AGENDA
HAILEY PLANNING & ZONING COMMISSION
Monday, May 3, 2021
Virtual Meeting
5:30 p.m.

FINDINGS OF FACT, CONCLUSIONS OF LAW AND DECISION

On April 19, 2021, the Hailey Planning and Zoning Commission considered and approved a Design Review Application by Antony and Sarah Gray for a new 2,742 square foot single-story residence. This project is located at 121 North 3rd Avenue (Lots 1-4, Block 38, Hailey Townsite) within the Limited Residential (LR-1) and Townsite Overlay (TO) Zoning Districts.

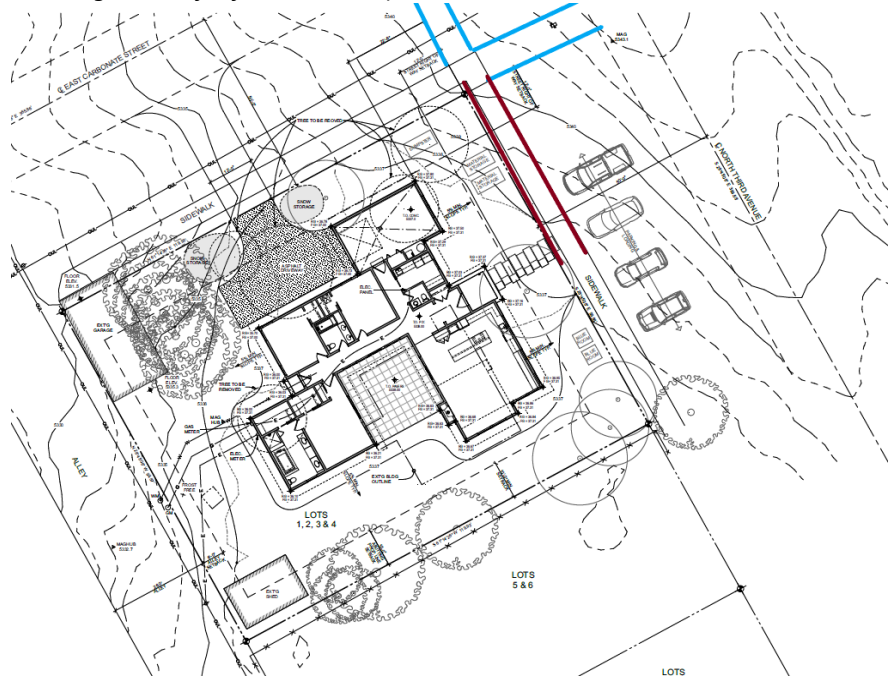
Application: The Applicant is proposing to construct a new 2,742 square foot single-family residence, which includes an attached garage, at 121 North 3rd Avenue. This is a corner lot. Access for the existing historic residence is located on Third Avenue. The existing residence will be relocated to another site in Hailey, and the two outbuildings, labeled 'garage' and 'shed', will remain onsite. This Application was heard by the Commission on March 1, 2021. The Applicant proposed that the garage gain access off of Third Avenue and not the alley, as called for in the TO District, and as noted herein.

As a general rule (pursuant Section 17.06.090(C)4 of the Hailey Municipal Code), garages and parking areas should be accessed from the alley side of the property and not the street side. Per feedback from the Commission at the March 1, 2021 public hearing, the Commission recommended that the Applicant look at reconfiguring the site plan to meet the standard or draft an alternative design for the Commission's consideration. Further discussion of this standard can be found below.

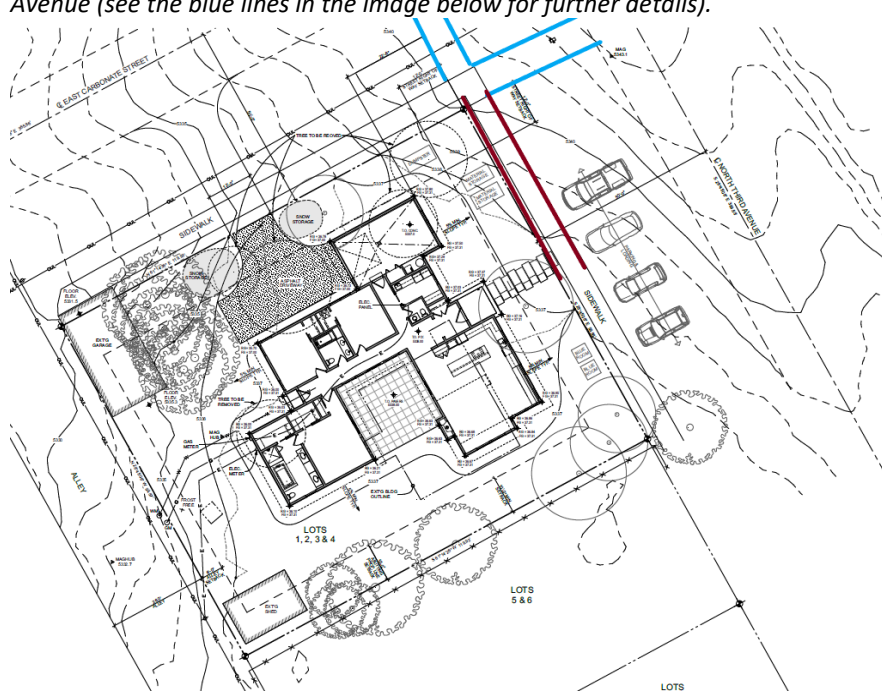
Staff Comments	<p>Maximum Building Height: 30'</p> <p>Proposed Building Height: 18'-1 5/8"</p> <p>Proposed Setbacks:</p> <ul style="list-style-type: none"> ○ Front Yard (East): 22'-6" ○ Side Yard (North): 14' ○ Side Yard (South): 21' ○ Rear Yard (West): ~30' <p>Proposed Lot Coverage:</p> <ul style="list-style-type: none"> ○ 3,622 square feet (Proposed Footprint + Existing Garage Footprint) / 11,979 square foot lot = 30%

<i>The Commission found all setback, building height, and lot coverage requirements have been met.</i>
<input checked="" type="checkbox"/>	<input type="checkbox"/>	<input type="checkbox"/>	17.06.070(A)1 Street Improvements Required	Sidewalks and drainage improvements are required in all zoning districts, except as otherwise provided herein.
			Staff Comments	<p><i>Sidewalks are existing along the property frontage of Third Avenue and Carbonate Street. That said, the Public Works Department recommended and the Commission concurred that the sidewalk along Carbonate Street and Third Avenue be extended to the edge of asphalt on both Carbonate Street and Third Avenue (see the blue lines in the image below for further details).</i></p>  <p><i>The Commission found that the existing driveway, off of Third Avenue, be removed and the area be revegetated, and that the sidewalk along the property frontage and where the previous driveway was, be installed/repared/replaced (see the red lines in the image above for further details). The existing sidewalks may also need some repairing. The Applicant shall repair the existing sidewalks, as outlined by the Public Works Department, prior to issuance of a Certificate of Occupancy.</i></p> <p><i>Furthermore, a detailed engineering plan with grading and drainage shall be provided prior to issuance of a Building Permit. The Public Works Department will need to review the final design before additional recommendations can be made.</i></p> <p><i>Comments above have been made Conditions of Approval and the Commission found this standard to be met.</i></p>

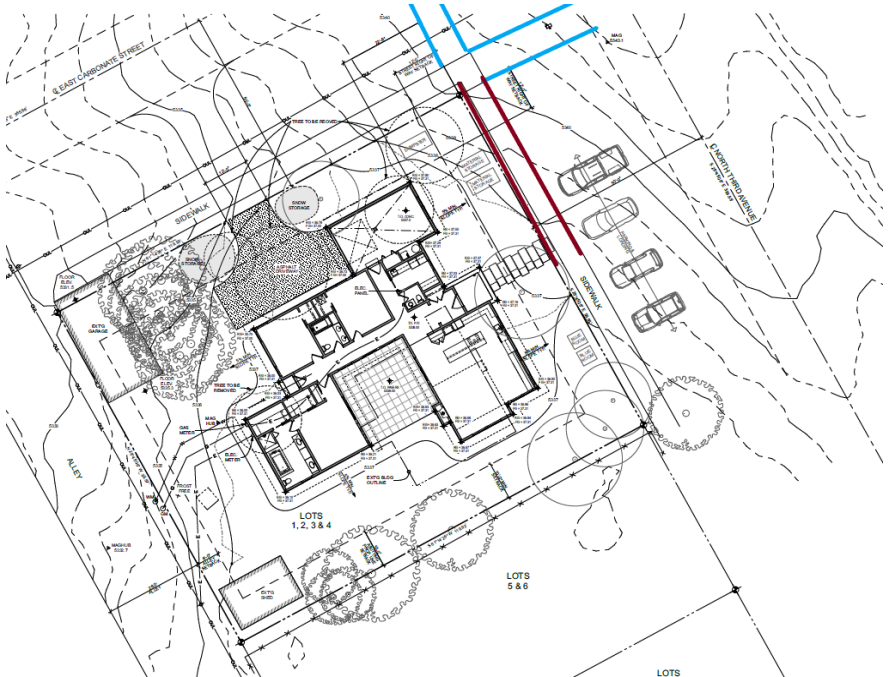
<p>Staff Comments</p> <p><i>Adequate parking has been provided. The existing driveway is 30' from the intersection of the two public roads, Third Avenue and Carbonate Street. In the original design, the Applicant proposed that the garage gain access from Third Avenue, where the driveway is approximately 14' from the intersection of these roads. Due to the proximity of the proposed driveway to the intersection, the Commission noted that, in addition to being inconsistent with Design Review Guidelines which direct vehicular access to alleys, the proposed driveway and garage would impede visibility of vehicular and pedestrian traffic coming from Third Avenue and Carbonate Street. The Commission strongly encouraged the Applicant to position the proposed garage and driveway off of the alley or reconfigure the site in differently.</i></p> <p><i>The Public Works Department also recommended and the Commission concurred that the sidewalk along Carbonate Street and Third Avenue be extended to the edge of asphalt on both Carbonate Street and Third Avenue (see the blue lines in the image below for further details).</i></p>  <p><i>With the new configuration, the Applicant is proposing that the garage door face the alley; however, access be achieved from Carbonate Street. The Commission felt this reconfiguration was a more appropriate alternative to the original proposal.</i></p> <p><i>The Commission also found that the existing driveway, off of Third Avenue, be removed and the area be revegetated, and that the sidewalk along the property frontage and where the previous driveway was, be installed/repaired/replaced (see the red lines in the image above for further details). The existing sidewalks may also need some repairing. The Applicant shall repair the existing sidewalks, as outlined by the Public Works Department, prior to issuance of a Certificate of Occupancy.</i></p>

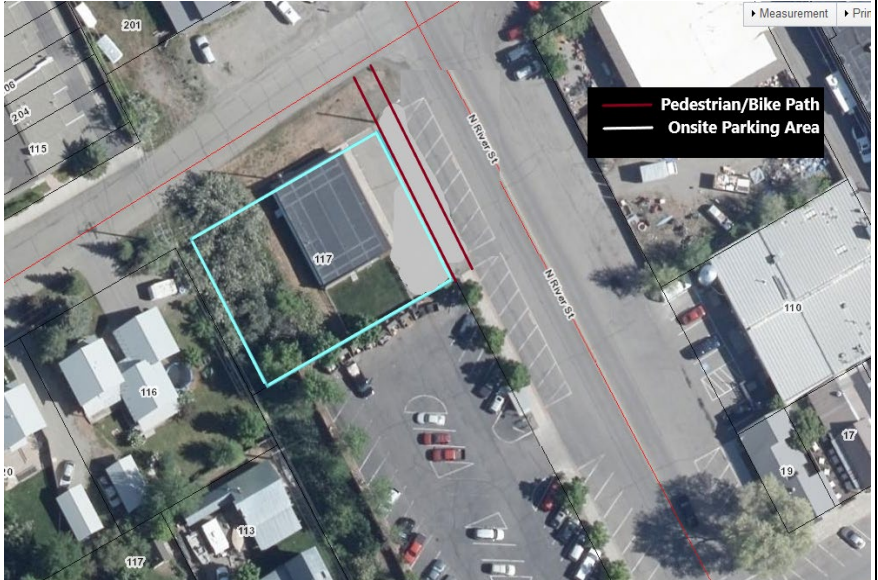
<input checked="" type="checkbox"/>	<input type="checkbox"/>	<input type="checkbox"/>	<p>17.09.040 On-site Parking Req.</p> <p>See Section 17.09.040 for applicable code.</p>	
			<p>Staff Comments</p> <p><i>The Hailey Municipal Code requires one (1) parking space for every 1,000 square feet of commercial space and one (1) loading space for retail, wholesale or warehouse occupancy with a floor area in excess of 4,000 square feet. The building is approximately 2,550 square feet; thereby, two (2) parking spaces are required. Per the site plan, five (5) parking spaces and one (1) loading space are available onsite.</i></p>

<i>The existing parking is sufficient and will meet the unique needs of the proposed use.</i>
<input checked="" type="checkbox"/>	<input type="checkbox"/>	<input type="checkbox"/>	17.09.020.08(B)	<p>B. Where alleys exist, access to on-site parking for any non-residential use or for any multifamily dwelling of three or more units shall be from the alley. Parking areas adjacent to alleys may be designed to allow a vehicle to back from the parking area into the alley.</p>
			Staff Comments	<p><i>An alley has been designated in GIS as existing; however, is impermeable due to existing mature landscaping and it is substandard in width. The alley has not been utilized, nor does it service the subject parcel. Vehicular approaches to the site can be achieved from River Street via an uncontrolled curb cut. Staff concurs that the site is not serviced by an alley and that the approach, via River Street, is existing and does not interfere with traffic in the surrounding area.</i></p> <p><i>It is important to note that the uncontrolled curb cut will be reconfigured when the River Street Master Plan is executed. An interim design is underway for River Street, to extend an asphalt bike path to the north until such time as a more complete streetscape can be executed. As part of the interim design, City Staff recommends that the Applicant locate onsite parking to the public right-of-way, and utilize the front parking area as additional patio and outdoor space. With this redesign, the sidewalk that ends just south of the parcel (at the Park-n-Ride) will be utilized as a pedestrian and bike path (see image below for further details). Sawtooth Brewery, the business located to the east and across River Street will also be reconfiguring their onsite parking to reflect the interim redesign, as noted above and shown below.</i></p> <p><i>Additionally, the Applicant is not responsible for executing and striping the parking area. The City will execute said changes and notify the Applicant prior to the reconfiguration.</i></p>
